REVIEWED FOR CODE COMPLIANCE
KELLY A. JANIS
WEBER COUNTY
BUILDING INSPECTION DEPARTMENT

PONDEROSA
WOLFCREEK - LOT 35

Project Information
3570 N. WILLOW CREEK LANE
EDEN, UT 84310
PINEVIEW VILLAGE LOT 35 - PONDEROSA

Sheet Information
FIRST FLOOR
ELECTRICAL PLAN

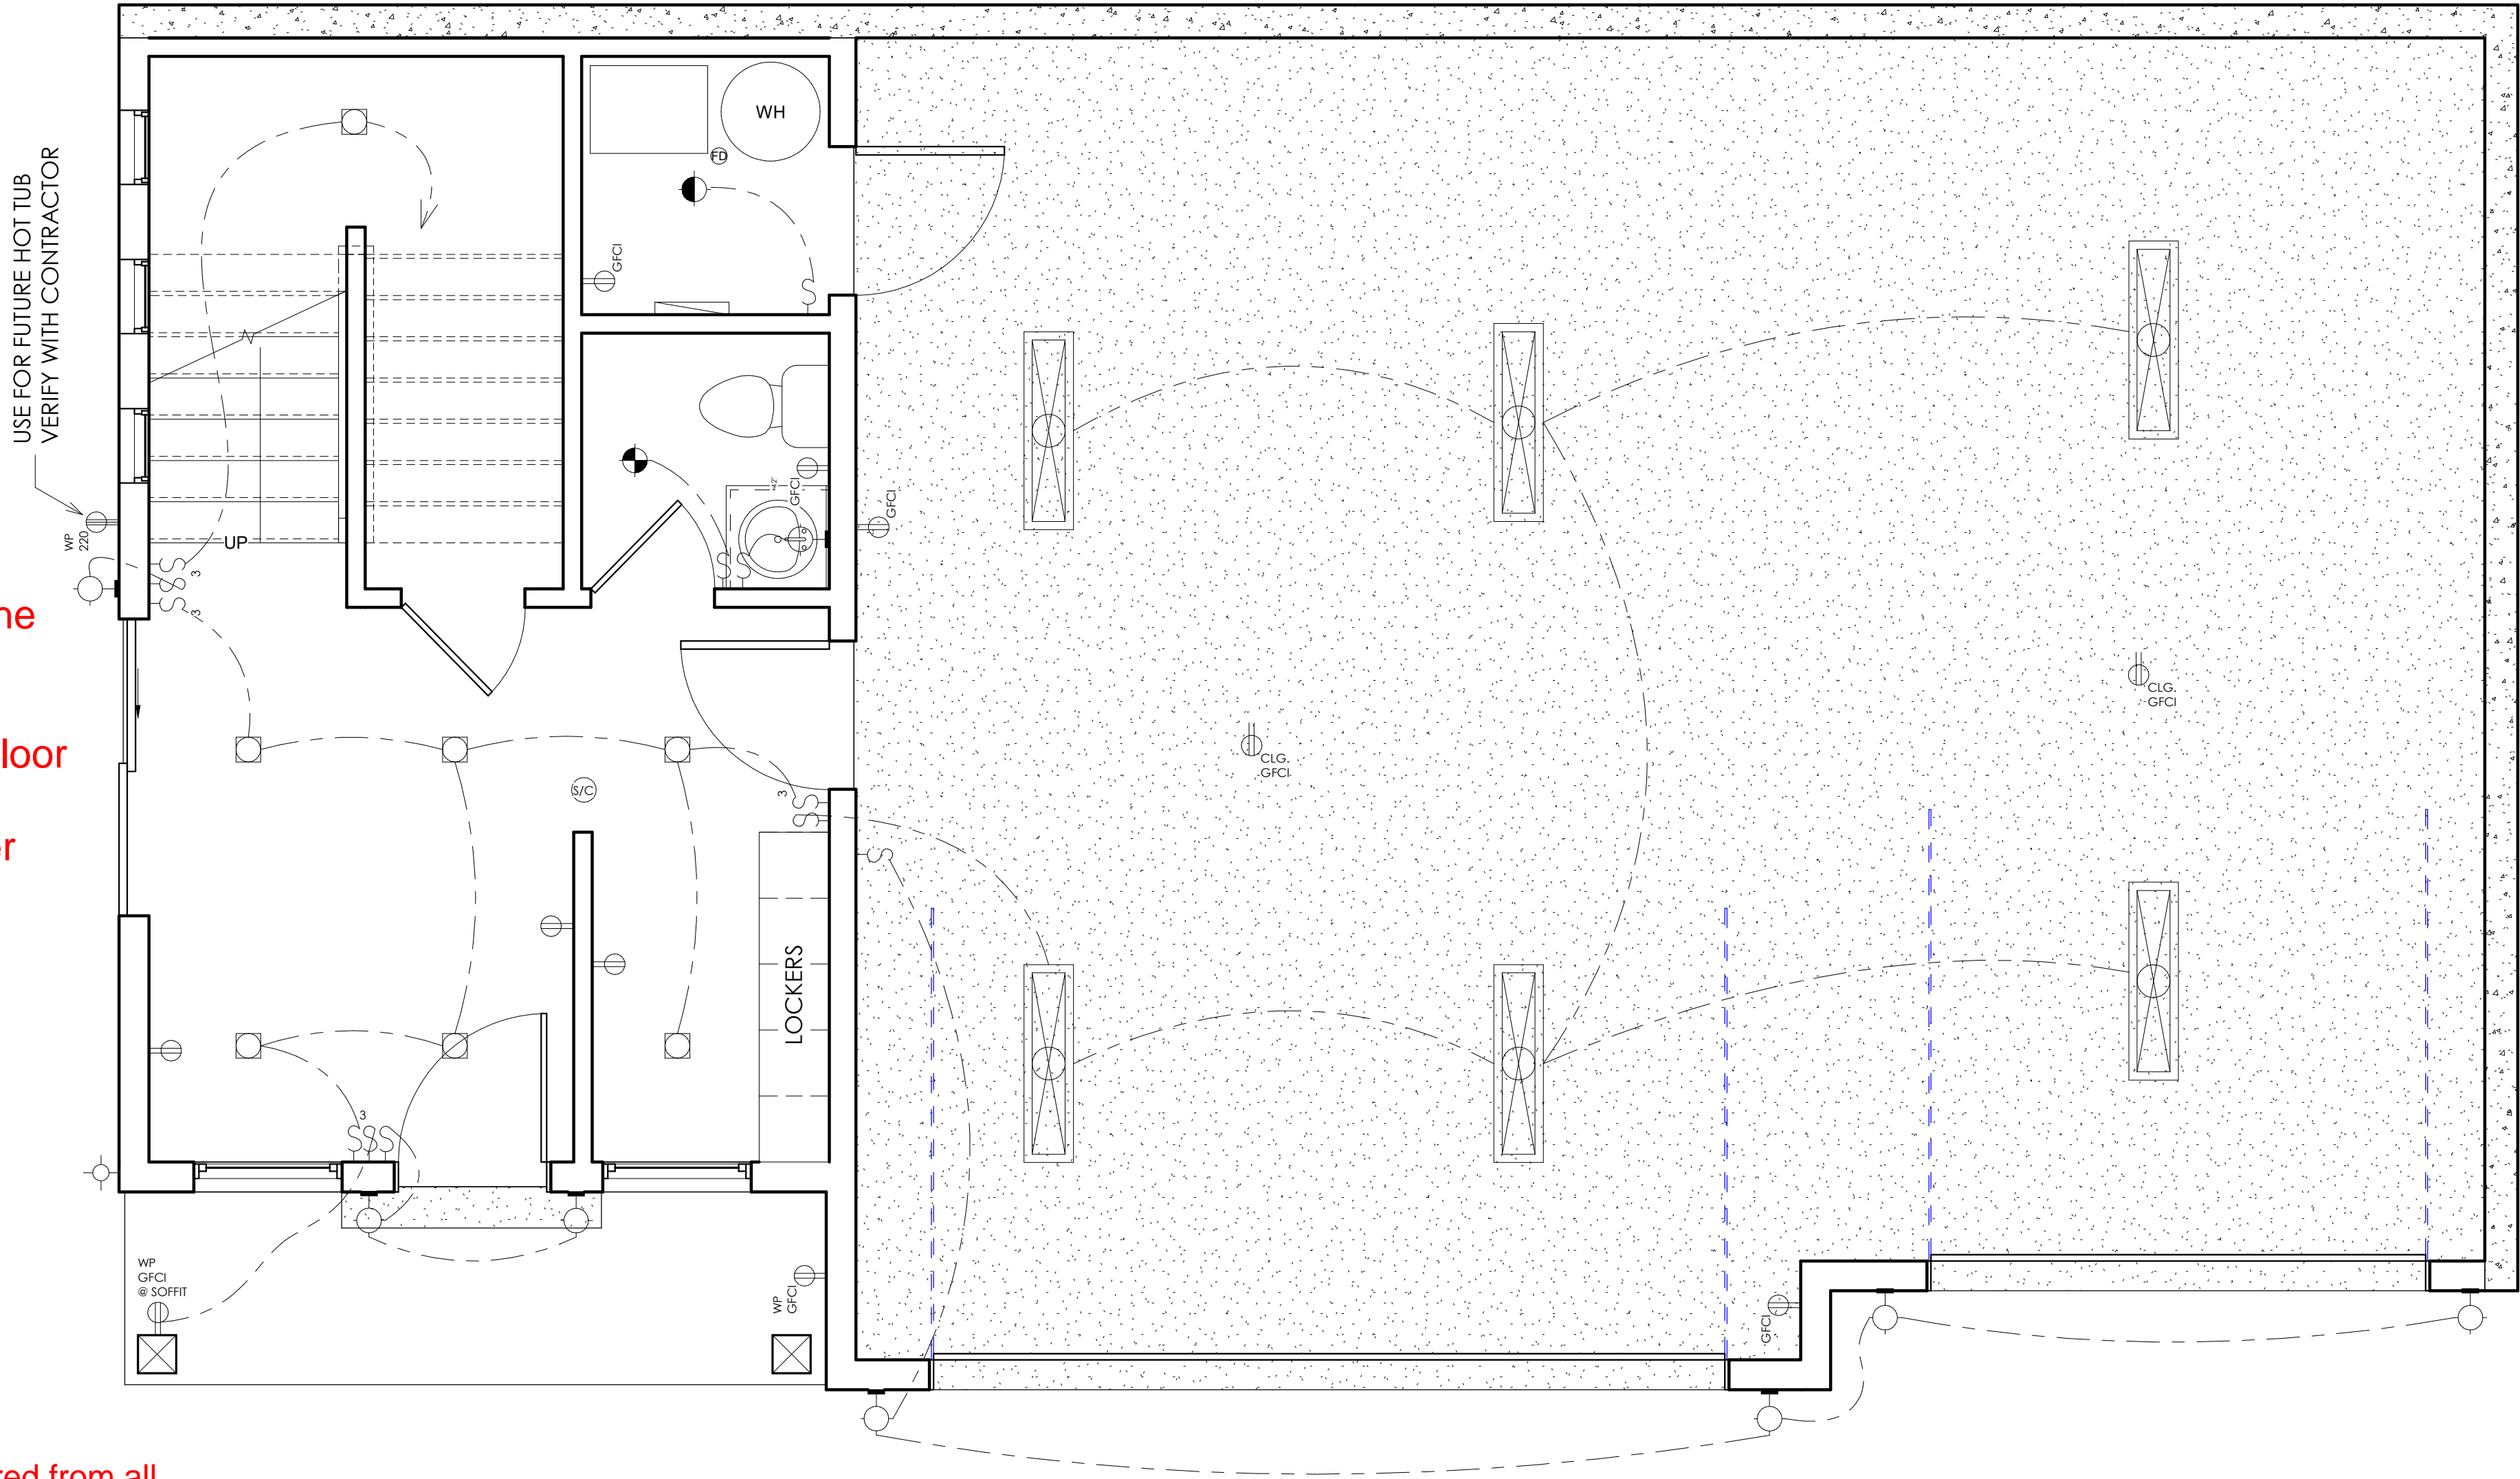
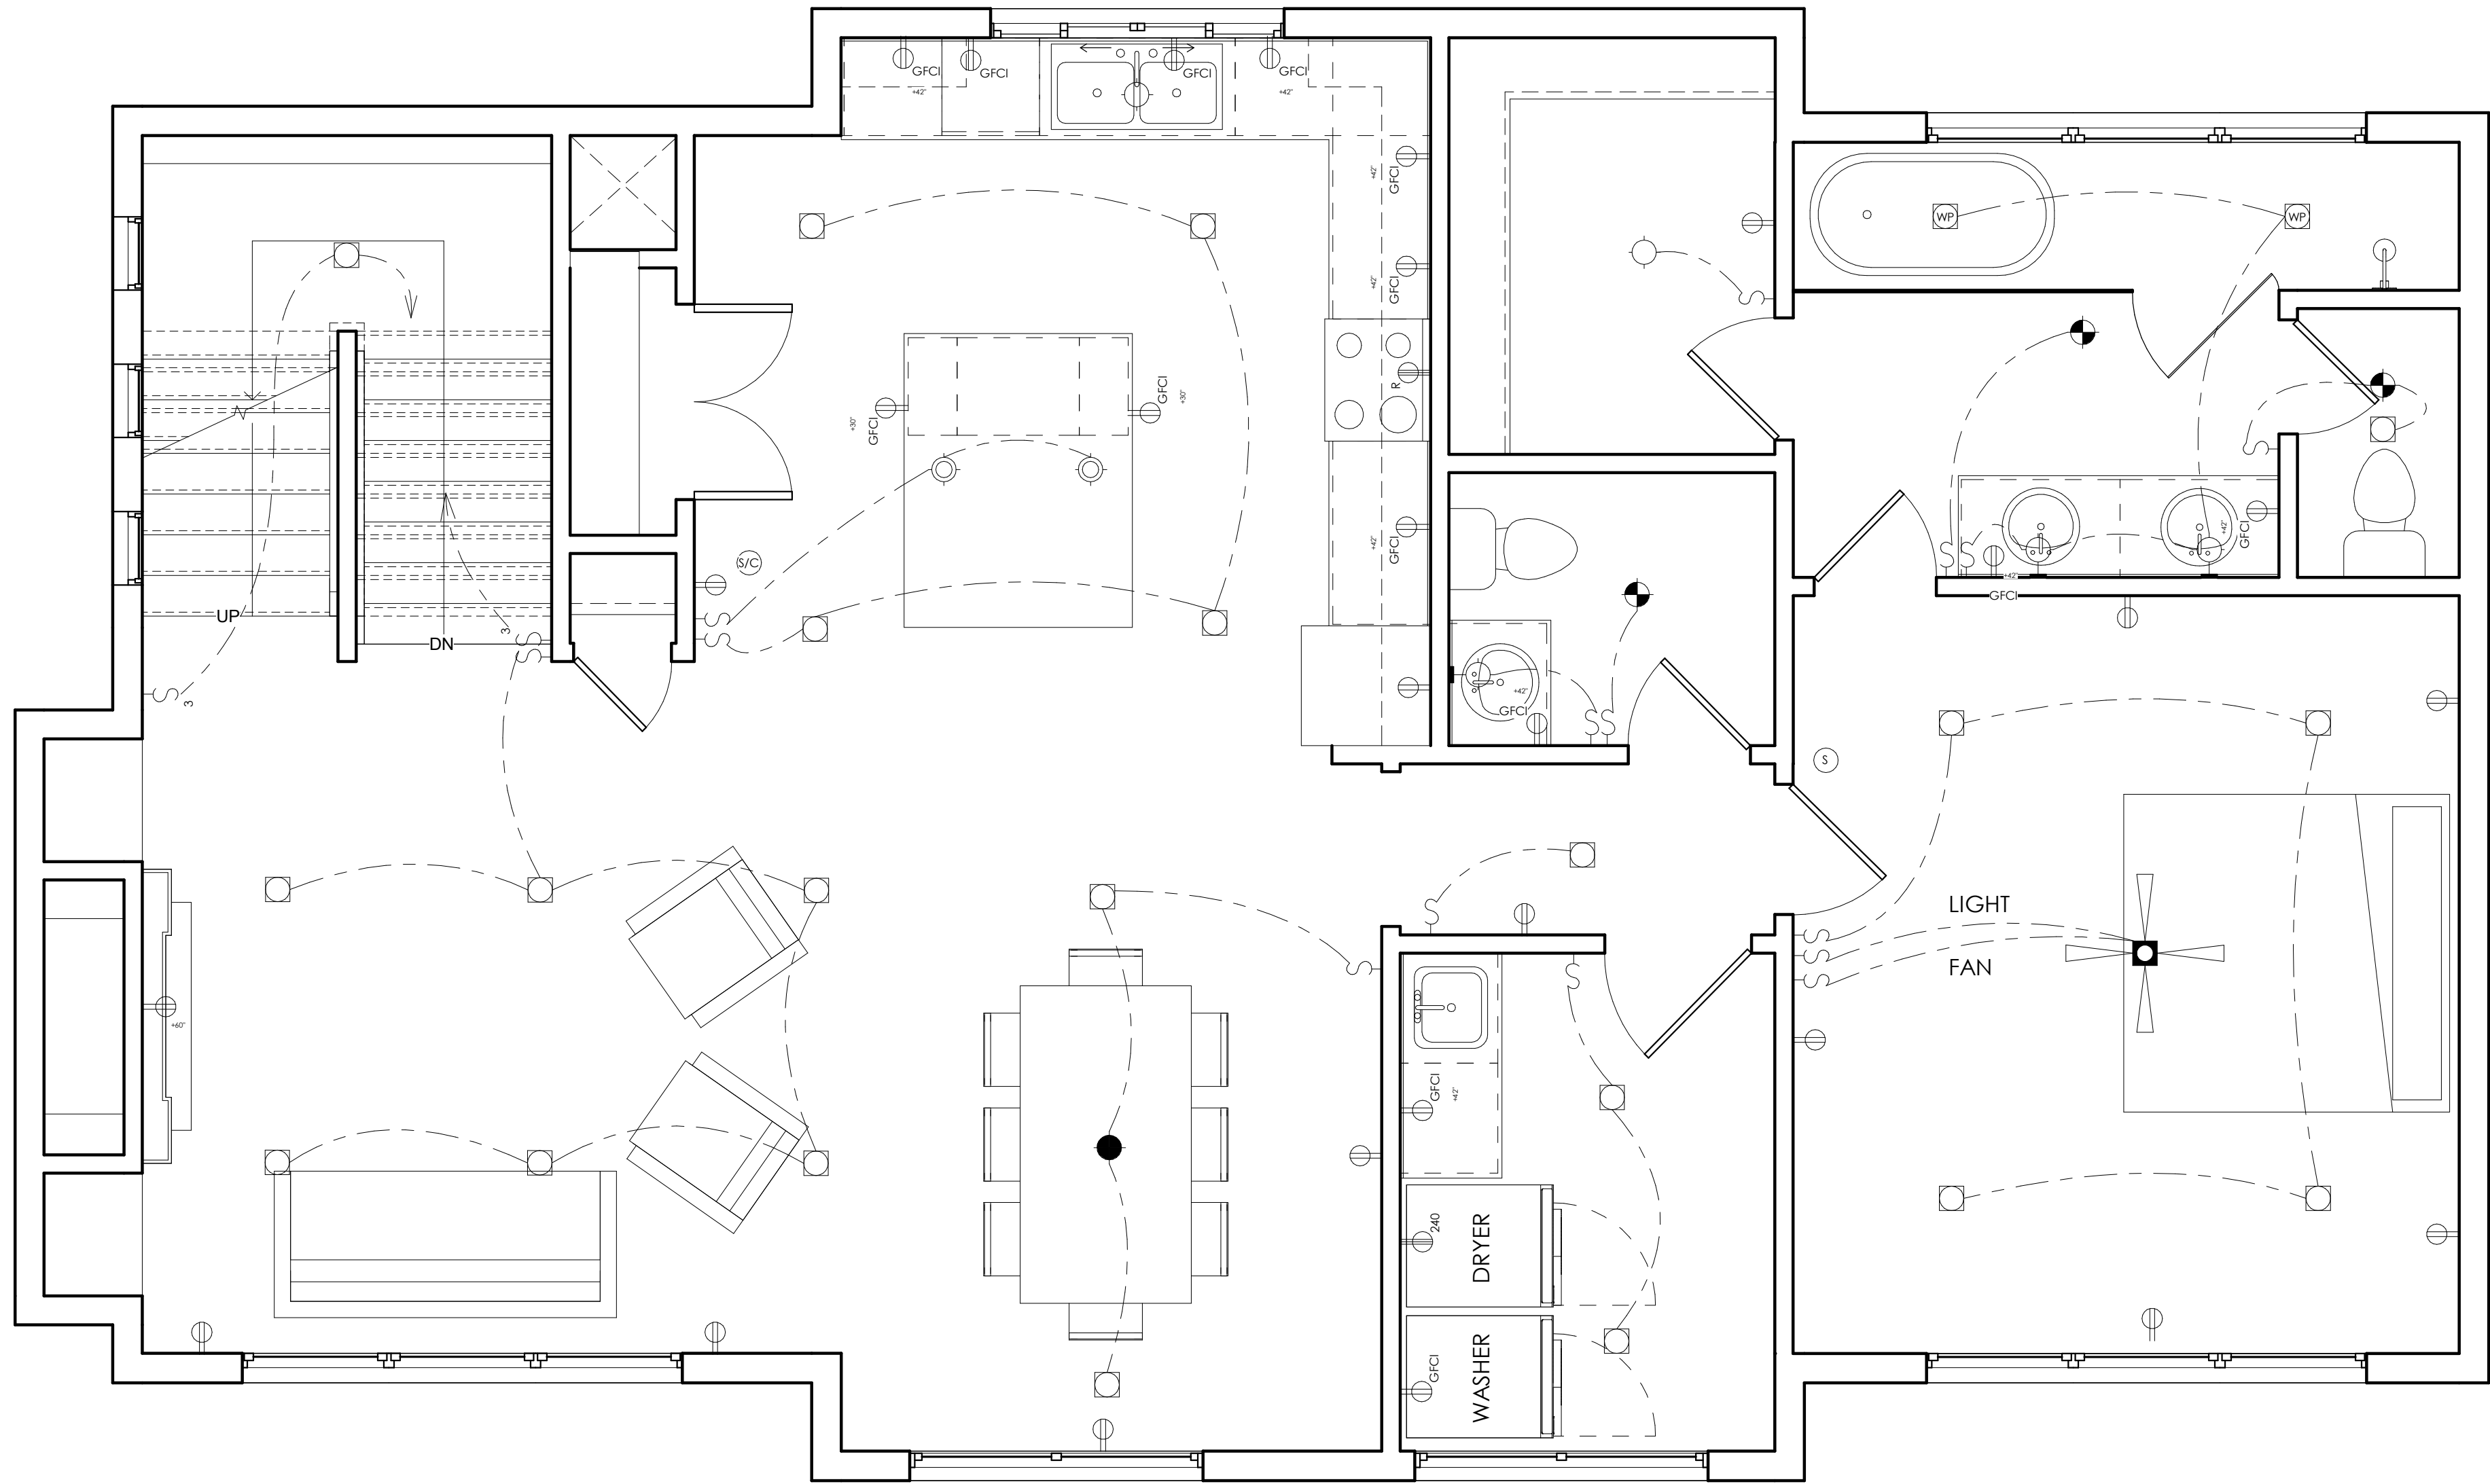
At least one lighting outlet controlled by a listed wall-mounted control device shall be installed to provide illumination on the exterior side of each outdoor egress door having grade level access, including outdoor egress doors for attached and detached garages with electrical power per IRC #3903.3.

Ground fault circuit interrupters shall be installed in a readily accessible location per IRC E3902.14.

All garage receptacles must be GFCI protected per IRC E3902.2.
